**CITY OF TACOMA**  
**Tacoma Power/Generation**

**ADDENDUM NO. 1**

**Request for Qualifications Specification No. PG20-0325F  
Cushman 2 Powerhouse Unit 31, 32 Rebuild Project**

DRAWING NO. MFR-B2-1045

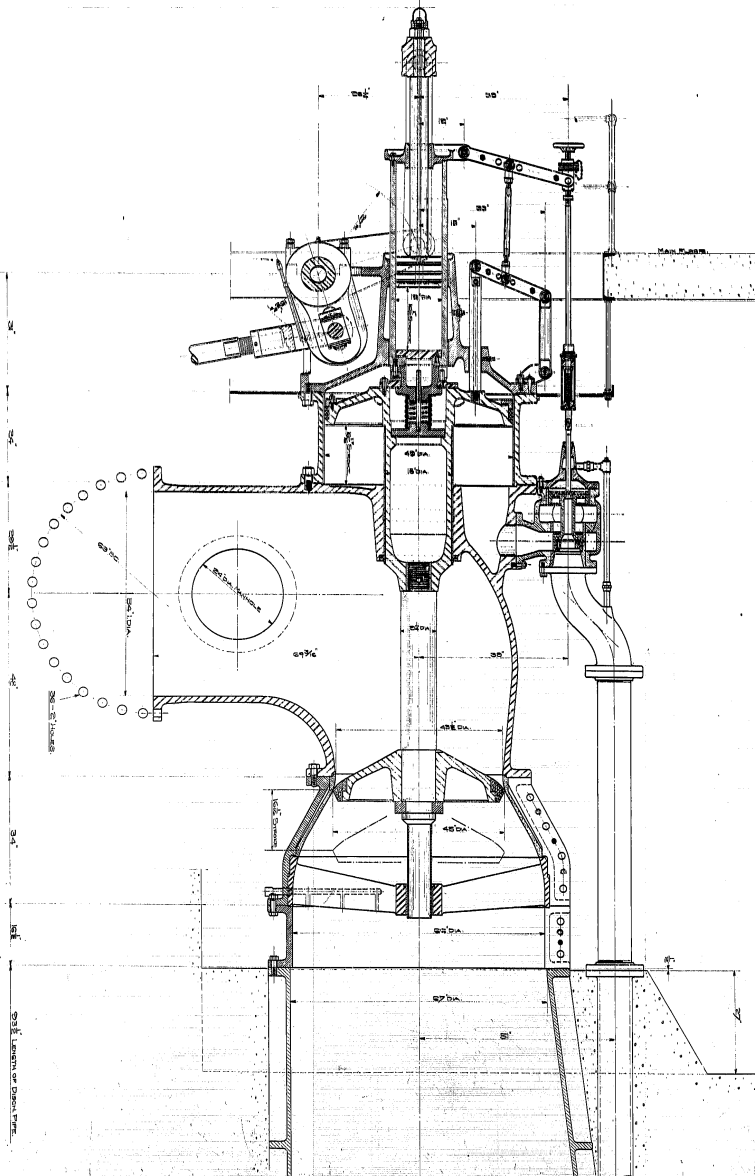
**Question 5:** Attachment A-1 Supplemental Bidder Responsibility Form under Minimum Experience requirement the last item "Performed refurbishment and commissioned a mushroom type, turbine pressure relief Valve". Can you supply a drawing and more technical information on this valve? All of the other items in this experience criteria are typical work scope in a turbine generator rehabilitation project for manufacturers. If the Design Build team has limited experience with this obscure type of valve and cannot check yes, will they be eliminated as a vendor from the RFP stage since this is minimum experience Criteria?

Answer 5: If the proposed Design-Build team does not have specific experience with the type of valve installed at Cushman they are encouraged to provide details on their experience on rehabilitation or replacement of other designs of turbine pressure relief valves. Failure to illustrate experience on a mushroom type turbine pressure relief valve is not grounds for elimination for consideration; however, no experience in rehabilitation or replacement of turbine pressure relief valves would be. A cross-section drawing is attached for reference.
